Product Announcement

EZ Dock Couplers **311010**
Composite Hardware Bolt **211003**
Composite Hardware Nut **22003**

Implementation Date: 03-20-09

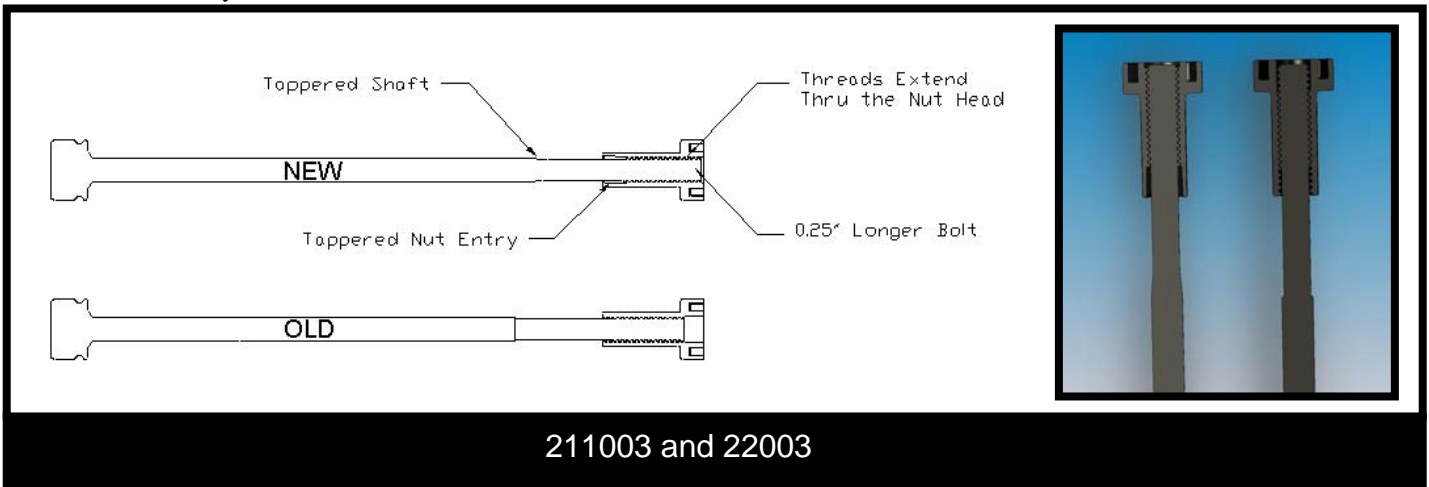
As an effort to improve our product line, EZ Dock has redesigned the couplers and composite hardware to increase durability and simplify installation. In the near future all new purchases will include these improved features. As the new components are released, each box will be identified with a large orange sticker to signify the newer revisions.

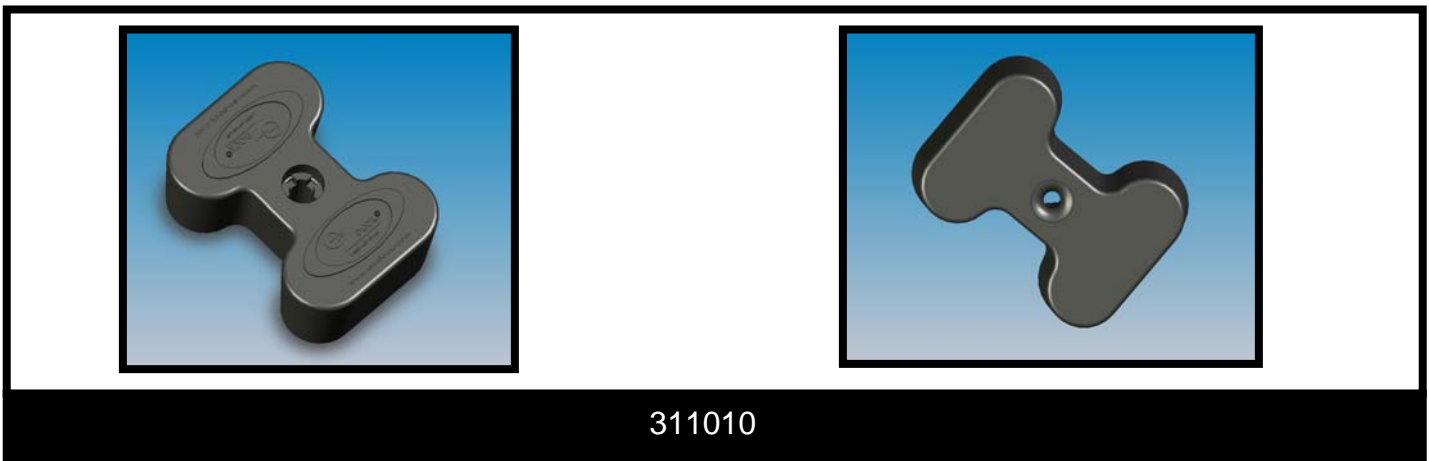
Composite Hardware- The coupler composite hardware nuts and bolts will have a few modifications. In the past, the threads of the nuts extended from the bottom of the nut and only up to the base of the nut head. This new revision will allow the threads to extend all the way through the nut head. This change will allow the full strength of the cross sectional area of the nut to support all transitional forces. In addition, the step on the shank of the bolt will now be tapered and bolts will be 3/16" longer than before. These modifications will allow the coupler sets to have increased mechanical properties while still allowing the dock sections to function effectively.
